2022.01 ~03 Mass production inspection

Model Name: BFX-UA300

Document Version: ALT_STB_MP_CSMTINS_001

Issued Date: 2022.04.08

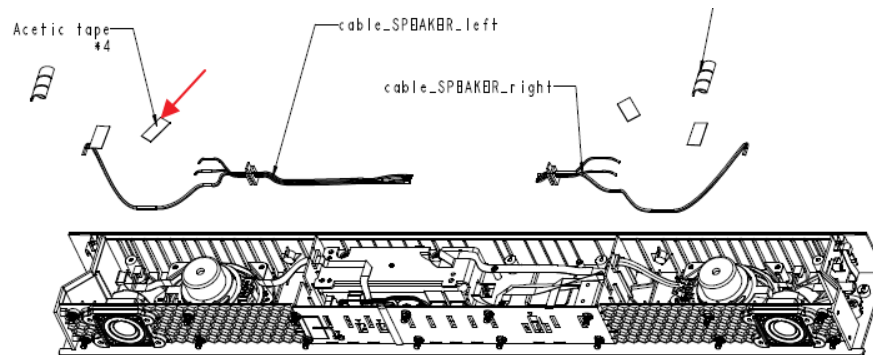
- Aux is not working
 - Issue grade : Critical
 - Symptom : Aux is not working
 - Defect unit Q'ty : 1pcs / 315 pcs
 - PCBA SN : YWN1ZXC
- ALT initial review
 - Aux is not working, R2945 and R2946 PCB pattern was broken
 - SW engineer review history
<https://mantis.cnsbg.foxconn.com/vas/view.php?id=1460>
- ALT Action
 - Replace the main PCBA
- Factory Action item
 - FXN should be submit 8D report
 - Need to update SOP and WI (Work Instruction)
 - Provide the preventive action

- KC label attachment NG

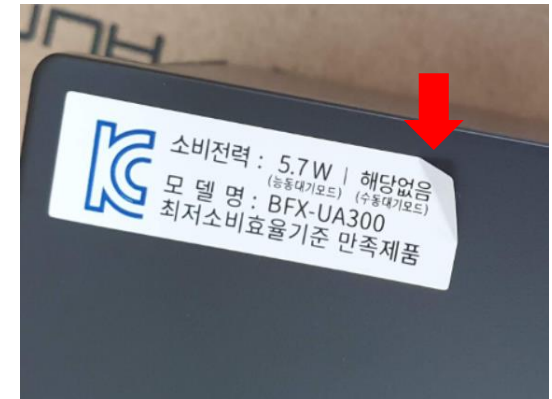
- Issue grade : Major
- Symptom
 - KC label is NG
 - Defect unit Q'ty : 1 / 315pcs
 - SN : 2149695001202109009361

- KC label NG

- FXN should be provided spear KC label
- FXN should be submit 8D report
 - Need to update SOP and WI (Work Instruction)
 - Provide the preventive action

- LED FFC bad assembly

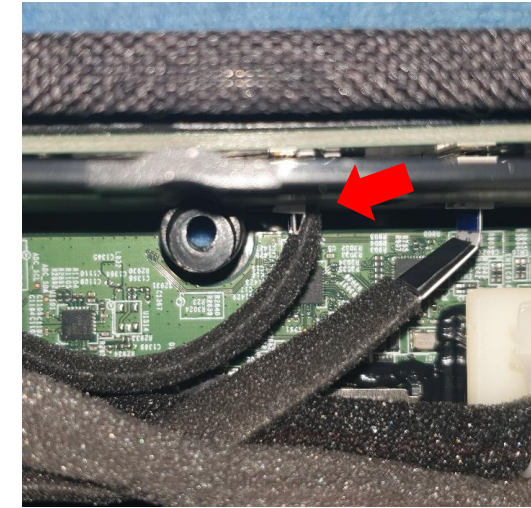
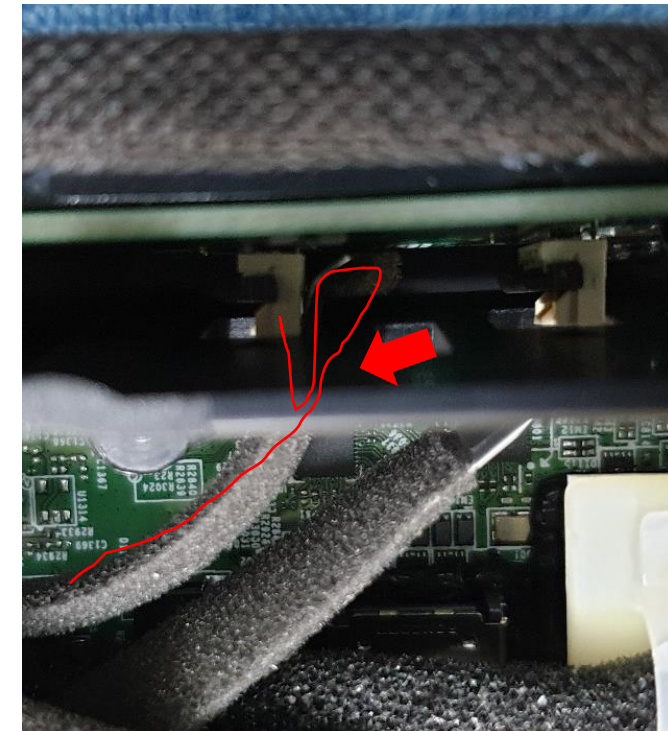
- The LED FFC cable was assembled with a bent
- Defect unit Q'ty : 1 / 315pcs
- SN : 214969500120202201005431

- LED FFC change

- FXN should be submit 8D report
 - Need to update SOP and WI (Work Instruction)
 - Provide the preventive action

- Inside the screw

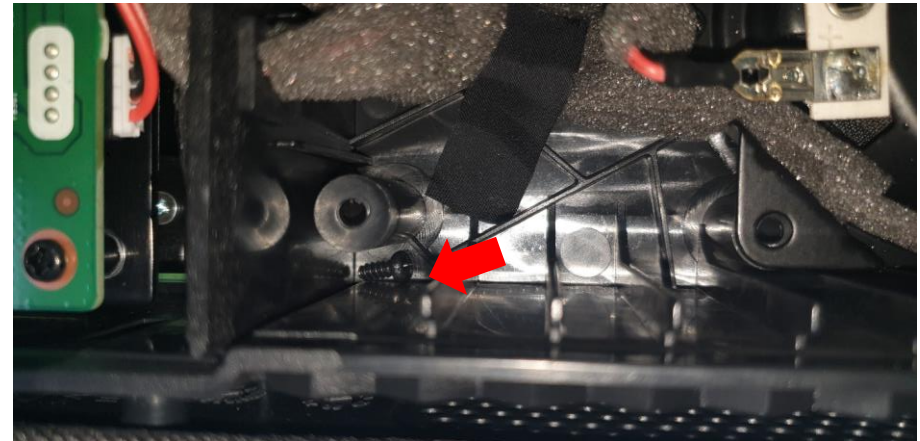
- A noise is heard when the product is shaken (Link)
- Defect unit Q'ty : 1 / 315pcs
- SN : 214969500120202201005431

- Remove the screw

- FXN should be submit 8D report
 - Need to update SOP and WI (Work Instruction)
 - Provide the preventive action – Add product shake test after final assembly

- Acetic tape miss align
 - Issue grade : Minor
 - Symptom
 - acetic tape miss align
 - Defect unit Q'ty : 1 / 315pcs
 - SN : 2149695001202109007608

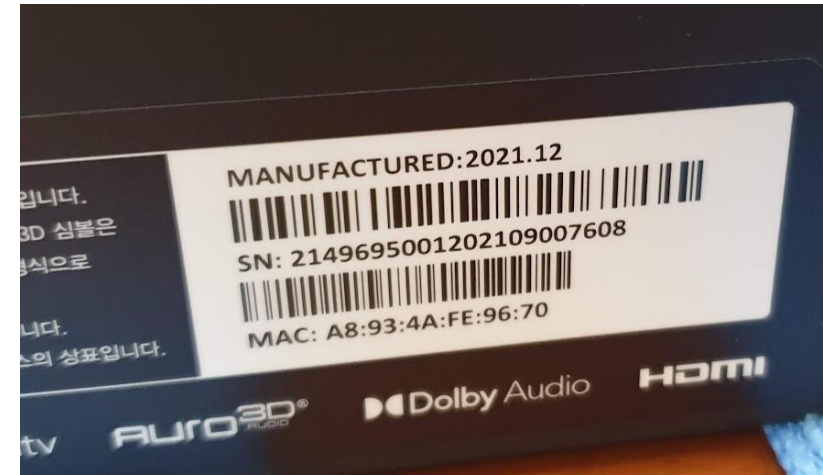
- ALT initial review
 - This miss align is make more rear side gap. (+ 0.1mm)

- Action item
 - FXN should be submit 8D report
 - Need to update SOP and WI (Work Instruction)
 - Provide the preventive action

- Grill assembly NG

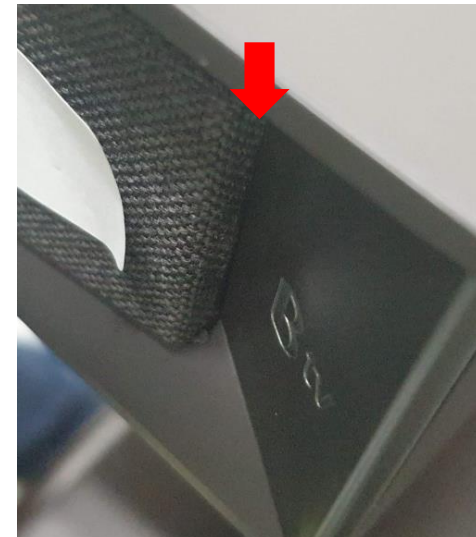
- Issue grade : Minor
- Symptom
 - Grill ass'y is not fully assembled
 - Defect unit Q'ty : 1 / 315pcs
 - SN : 2149695001202109008877

- ALT initial review
 - Grill ass'y was not fully push.
 - Re assembly the front Grill assy
- Action item
 - FXN should be submit 8D report
 - Need to update SOP and WI (Work Instruction)
 - Provide the preventive action

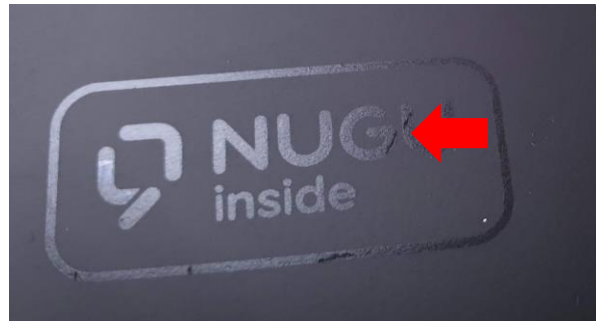
- Issue grade : Major
 - Symptom
 - NUGU logo painting NG
 - SN : 2149695001202109007608
- ALT initial review
 - Replace the Top housing

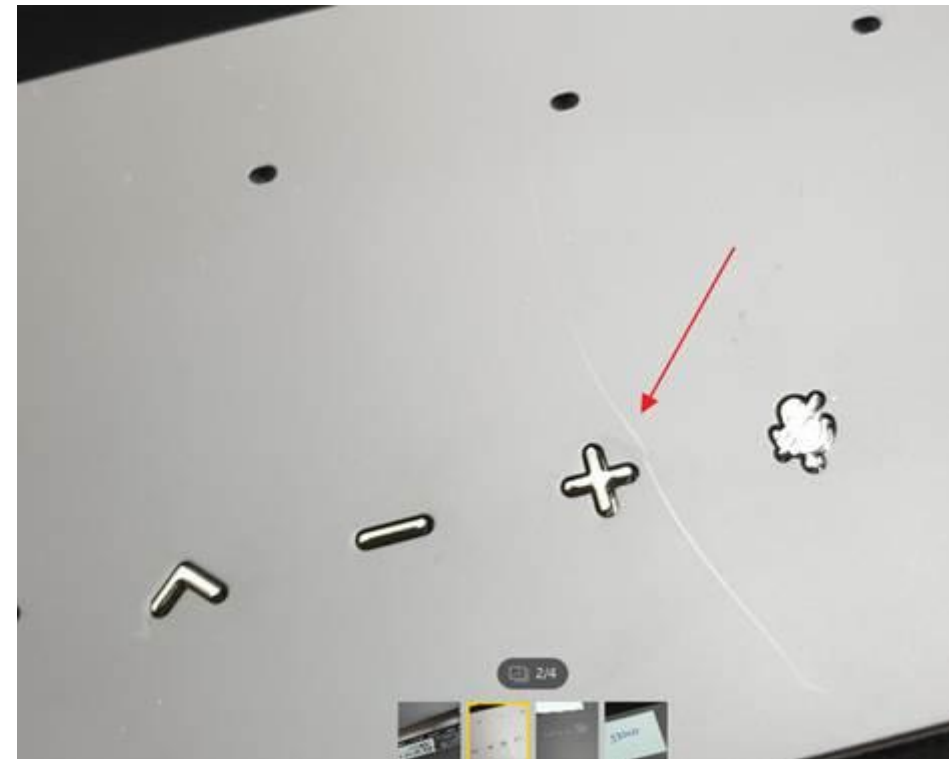
- Issue grade : Major
 - Symptom
 - Top case
 - SN : 2149695001202201005009

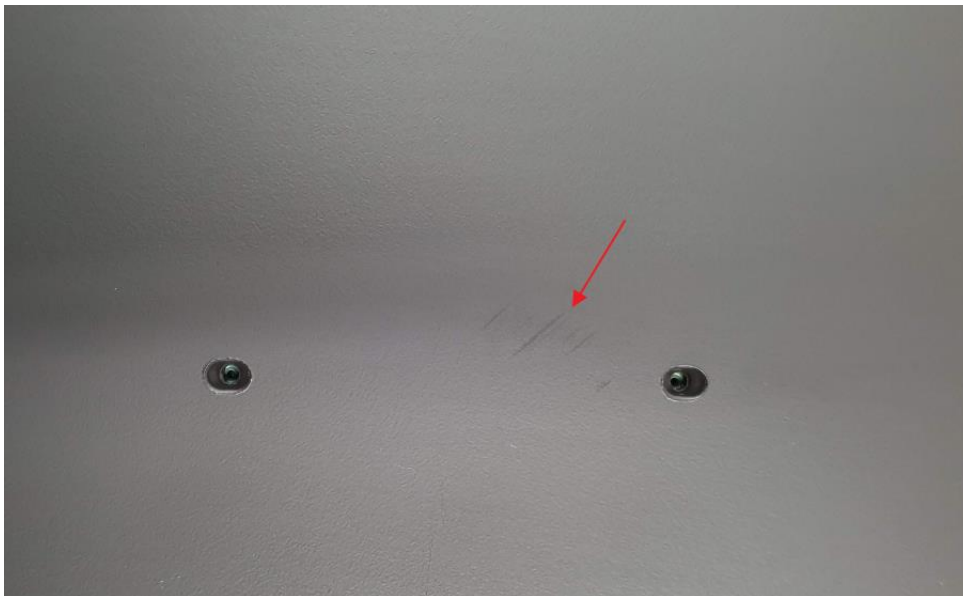
- Issue grade : Major
 - Symptom
 - Top case
 - SN : 2149695001202109008875

- Issue grade : Major
 - Symptom
 - Top case
 - SN : 2149695001202109009324

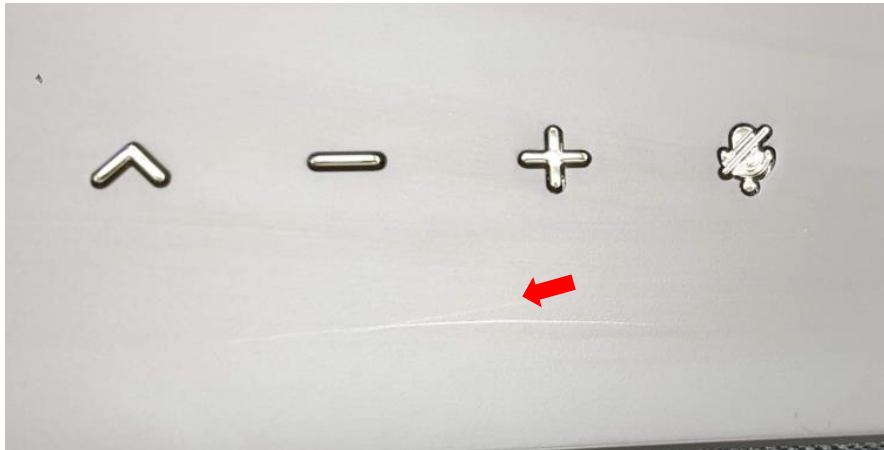
- Issue grade : Major
 - Symptom
 - Top case
 - SN : 2149695001202109009003

- Issue grade : Major
 - Symptom
 - Top case
 - SN : 2149695001202109009358

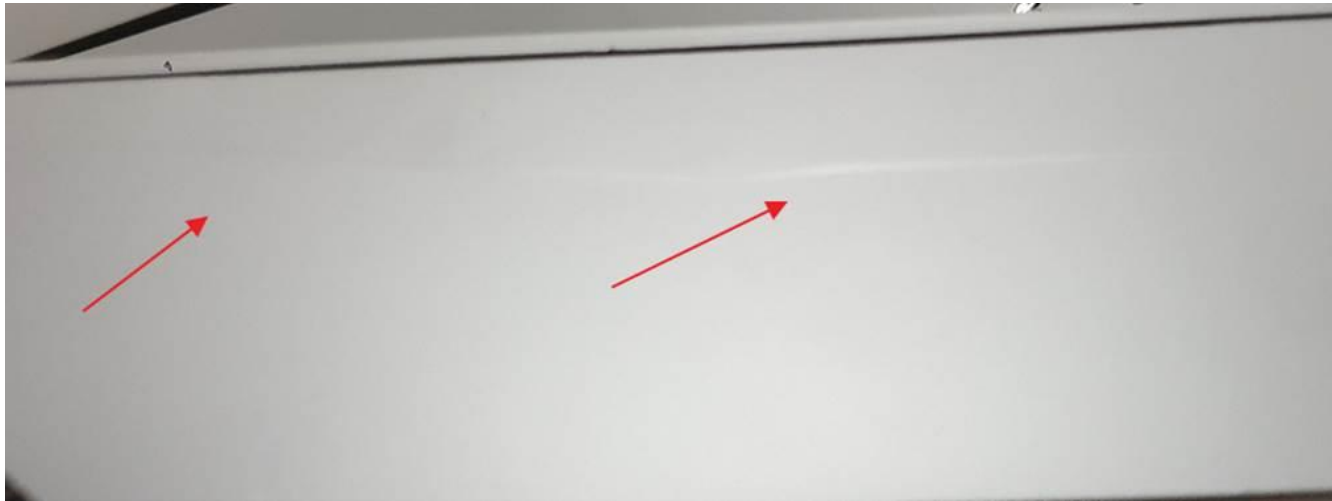
- Issue grade : Major
 - Symptom
 - Bottom case
 - SN : 2149695001202201005442

- Issue grade : Major
 - Symptom
 - Bottom case
 - SN : 2149695001202201005431
